Corrections & Updates

Ethermeter

March 2007, p. 72-74, 075035-I

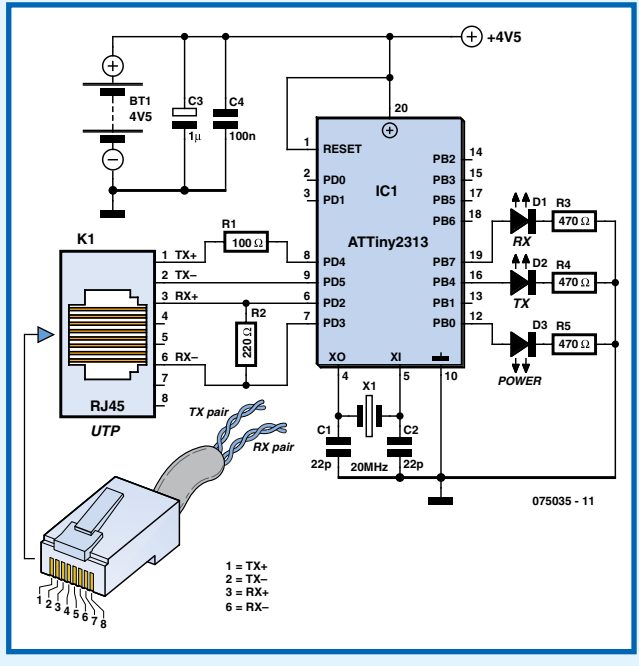
Due to a crashed hard disk in the author's PC an early version of the circuit diagram was printed. The correct schematic is reproduced here.
